Addendum # 2

Bid Opportunity: 25-7630-RFT - Laurentian Public School HVAC and Building Controls Upgrade

A202

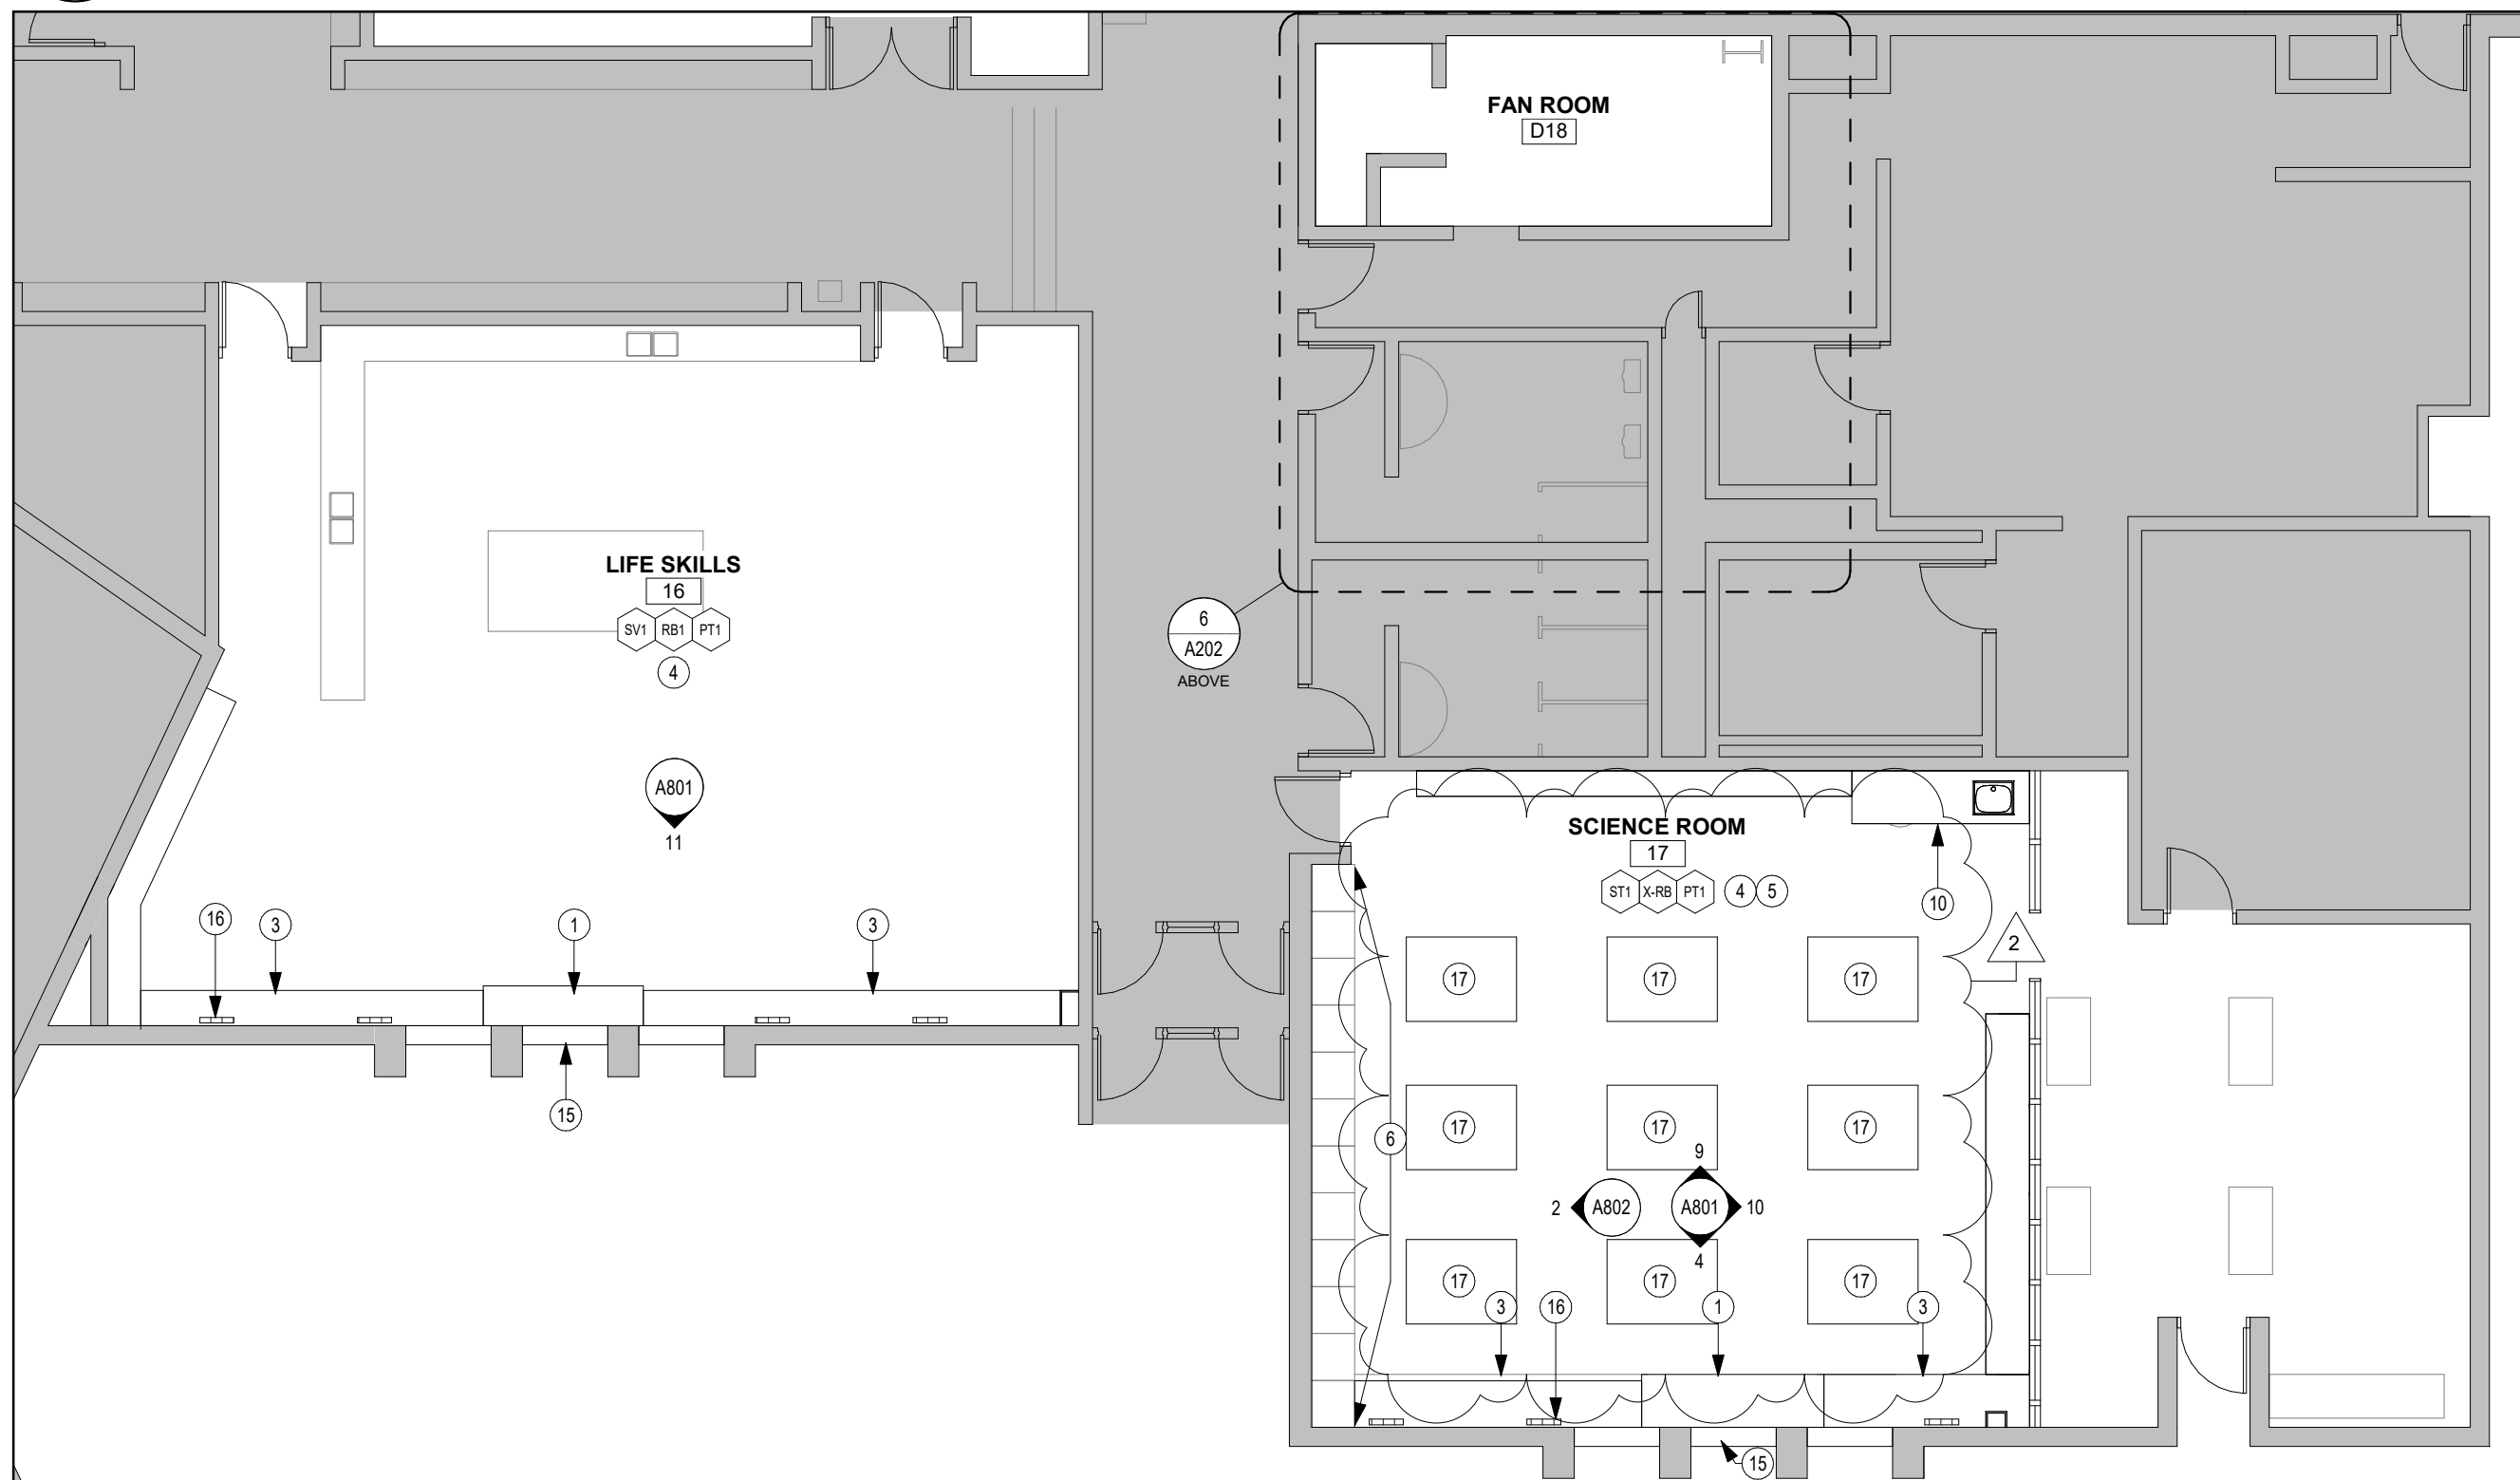
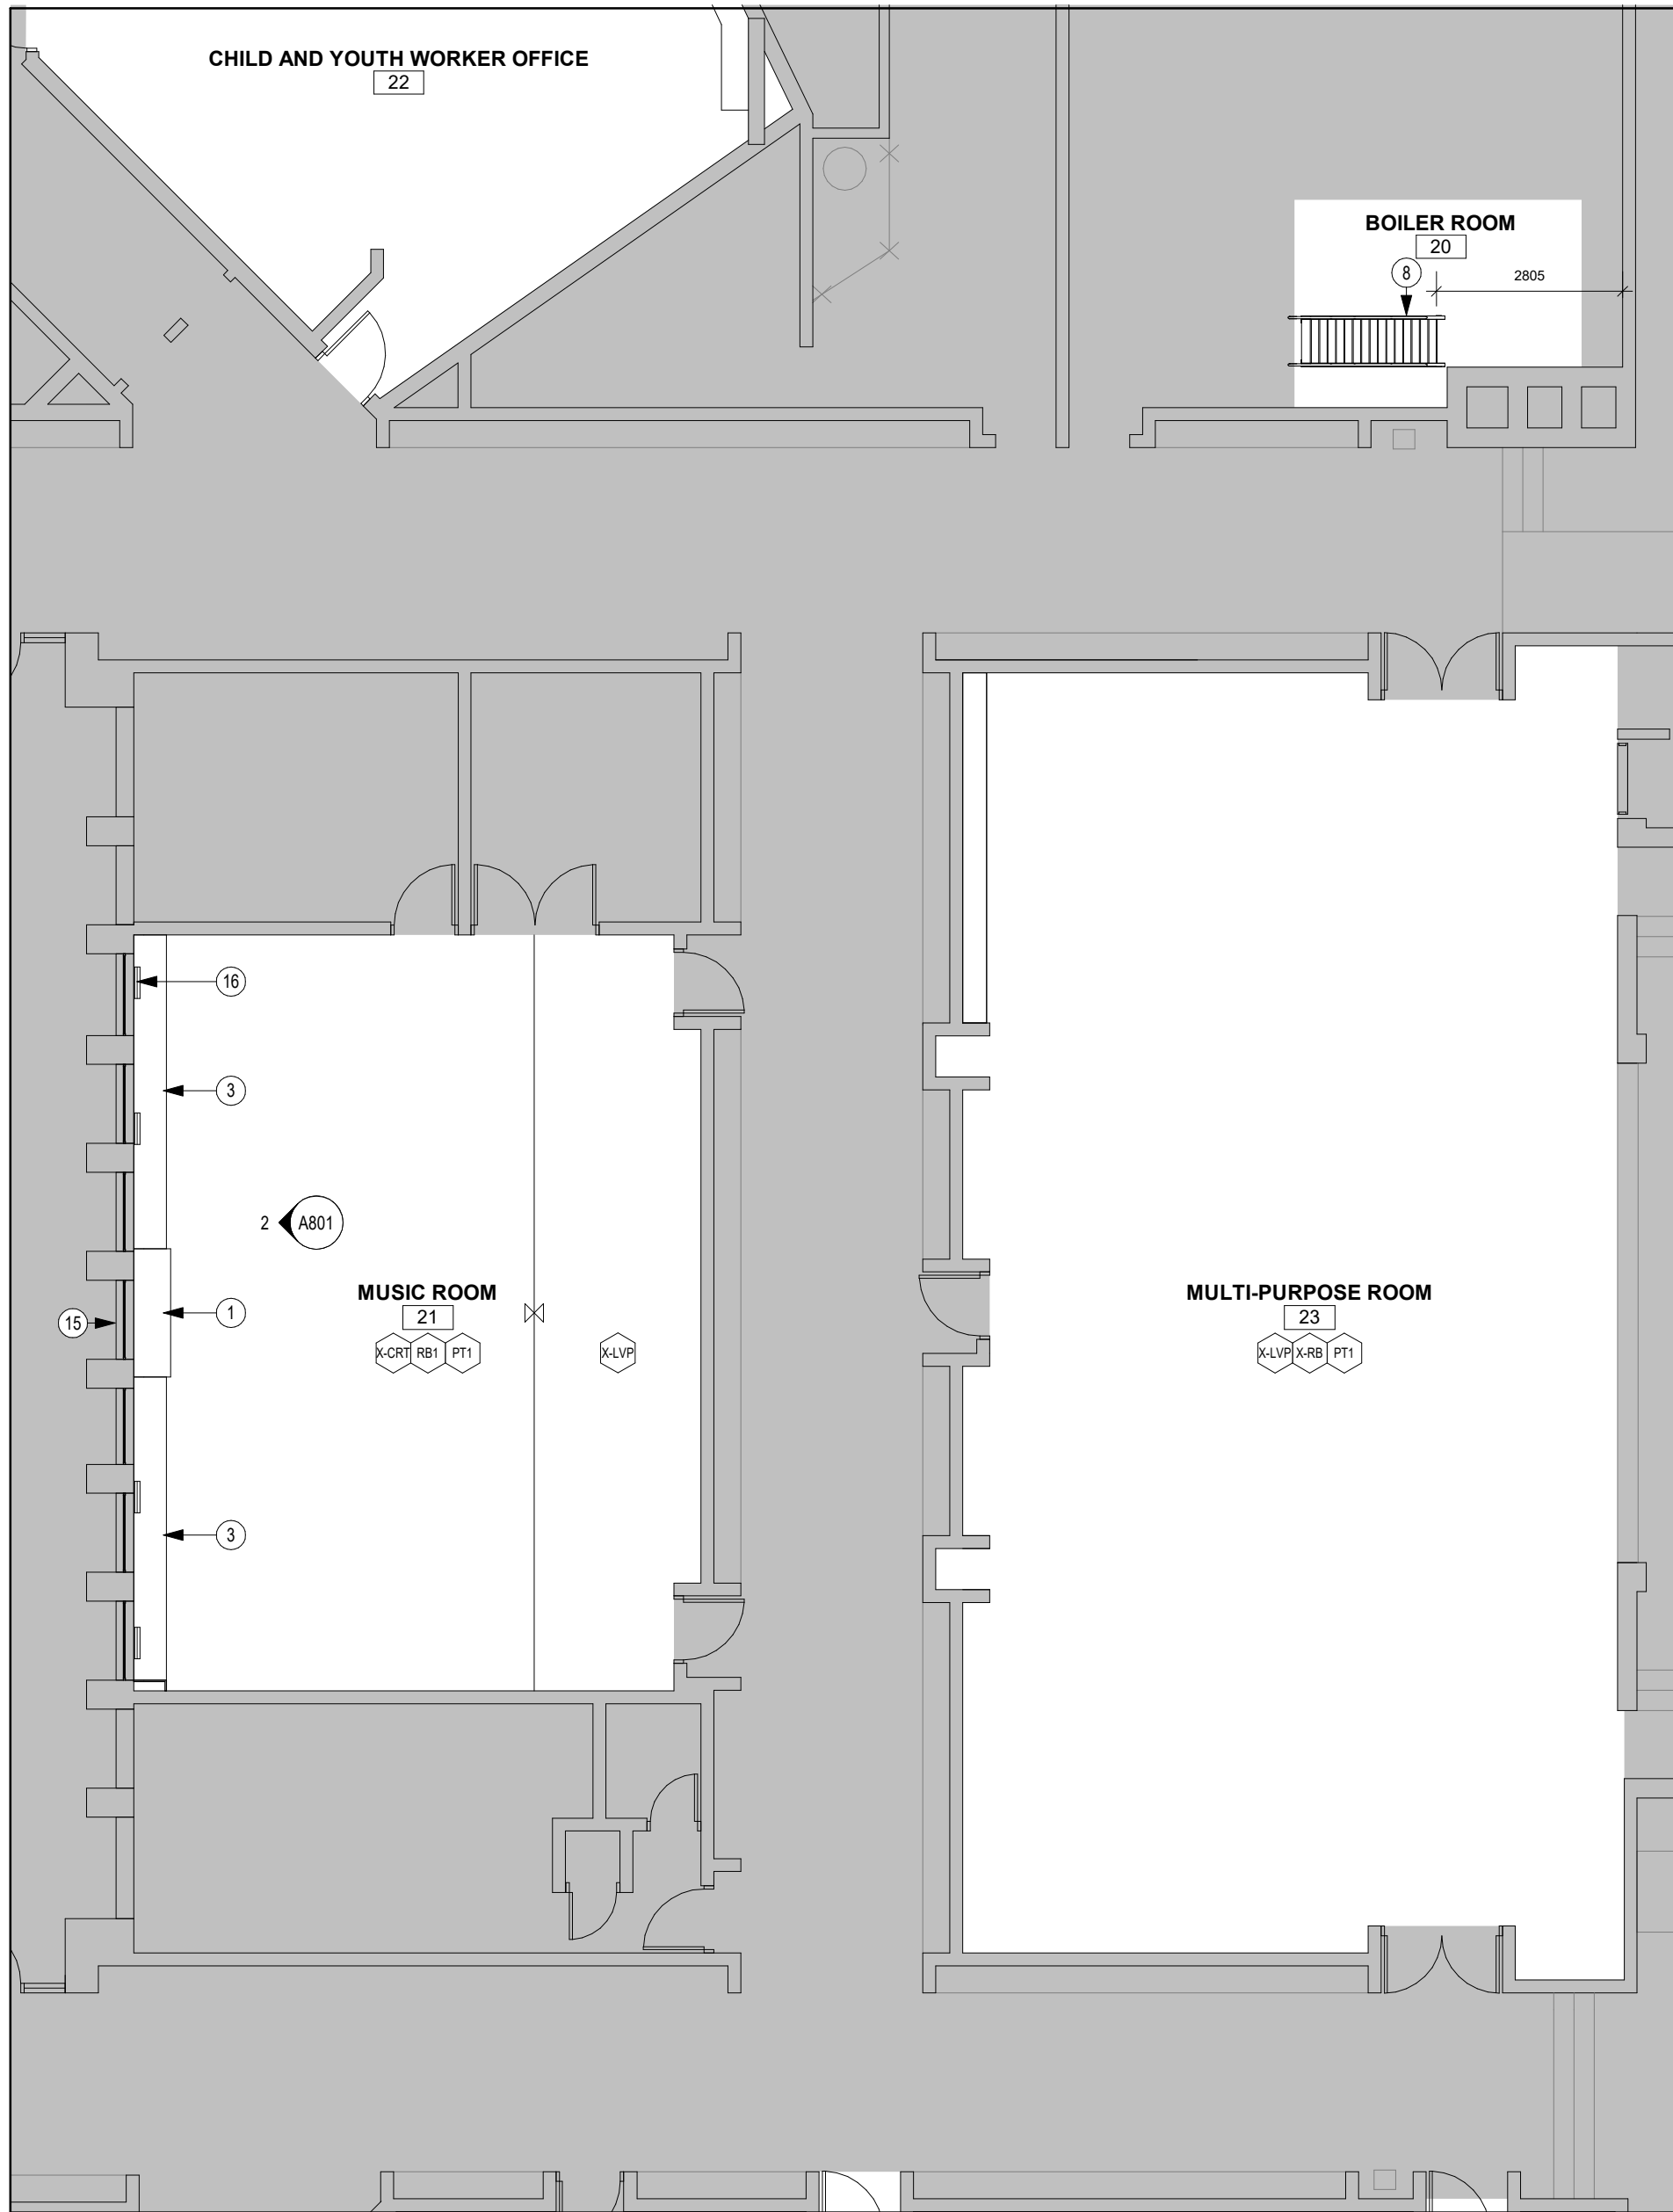
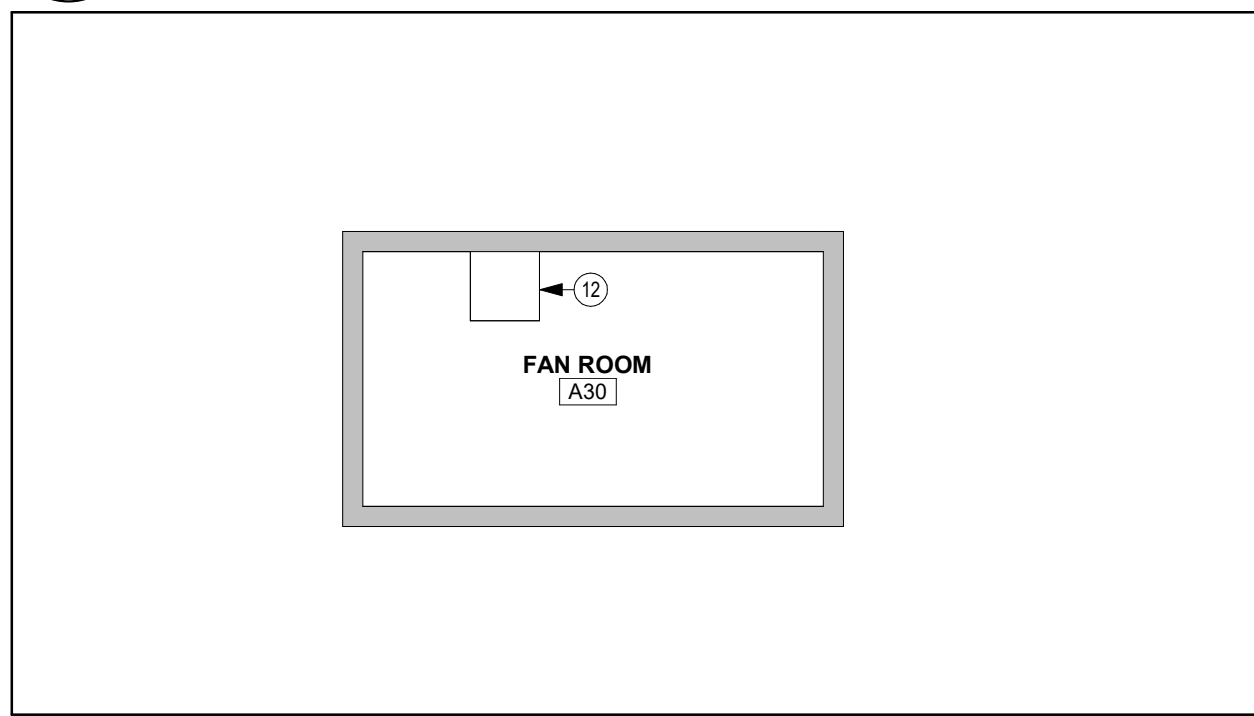
Delete reference to VCT1 from finish legend on A202.

Please provide a detail for note 12 on drawing A202. The structural and mechanical drawings do not have any details for this item.

Please provide a detail for the insulated panel louver infill note 13 on drawing A202 room D46.

Drawing A202 Partial Ground Floor Plan

1. In Science Room (17) added millwork elevation 2/A802. See attached drawing A201.
2. In Drawing Notes added drawing note 17 'Upon completion of wood floor re-finish, reinstall benches in same location. Reconnect electrical service. Refer to electrical drawing E501 for receptacle reconnect.'
3. In Science Room (17) added benches and drawing note 17.
4. Removed VCT1 from Finish Legend.

¼" thick plate to be used to cover existing duct openings being abandoned. Affix plate to existing concrete floor slab using ¼" concrete screws spaced at 6" minimum.

- UPON COMPLETION OF WOOD FLOOR RE-FINISH, REINSTALL BENCHES IN SAME LOCATION, RECONNECT ELECTRICAL SERVICE, REFER TO ELECTRICAL DRAWING E501 FOR RECEPTACLE RECONNECT.
